**CLIFTON PARK WATER AUTHORITY  
BOARD MEETING**

**Wednesday, June 16, 2021  
7:00 PM**

## **DISH Network Lease Proposal and Comparison to Existing Telecom Leases**

**From:** Jeff Szkolnik <jszkolnik@nbcllc.com>  
**Sent:** Tuesday, June 15, 2021 10:52 AM  
**To:** Don Austin  
**Subject:** RE: Proposed Verizon Wireless equipment modification - Knoll Top Water Tank - Consent Letter

LE-2

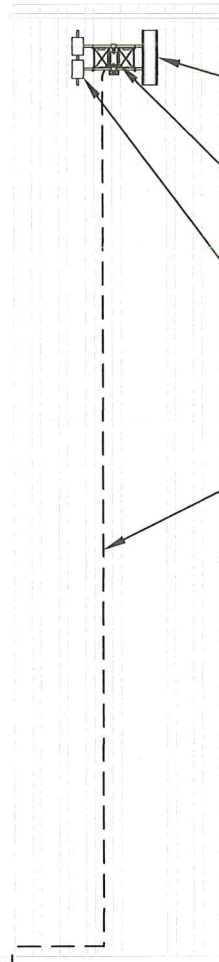
**STRUCTURAL NOTE:**  
STRUCTURAL ANALYSIS NOT COMPLETED AT TIME OF ISSUANCE  
OF THESE DRAWINGS. PASSING STRUCTURAL ANALYSIS  
REQUIRED PRIOR TO CONSTRUCTION.

For the structural calcs, please see below for a table of the change in loading for the proposed maintenance/upgrades

From the engineer: When completing the structural analysis, both additions in area and weight and the change in load is negligible when compared to the size of the tank, therefore the tank's structural capacity is essentially unaffected. I hope the board also agrees with this statement.

For what its worth, per our engineer: The current design proposes a new tieback at each mount framed back to the face of the tank. At that point Verizon would propose to stud weld a short angle which the tieback will bolt into. Each angle has 3 studs that will be adhered to the tank with the capacitor discharge method. This is done all the time on water tanks across the world and is the accepted method of attachment because it doesn't affect the inside face of the tank shell plate. I can add more notes if needed to the CDs, but this method is tested and proven to work over and over, and it's likely in place for all the mounts currently on this tank. I can say with 100% certainty none of the existing mounts on this tank are attached via magnets. Magnet attachments are generally 2'x2' or more, and all the attachments on this tank have plates that are only a few inches square. They are all welded or stud welded.

**From:** Don Austin [mailto:daustin@cpwa.org]  
**Sent:** Monday, June 14, 2021 9:41 AM  
**To:** Jeff Szkolnik <jszkolnik@nbcllc.com>  
**Subject:** RE: Proposed Verizon Wireless equipment modification - Knoll Top Water Tank - Consent Letter

For the structural calcs requested, I am merely looking for the changes in tank loading from the old equipment to the new. Our agreement with Verizon states "...Lessor agrees to any such modifications as long as the new equipment does not increase the loading of Lessor's water tank...". Significant additional loading may result in the CPWA wishing to renegotiate our contract, so I need to know what those increases, if any, are.
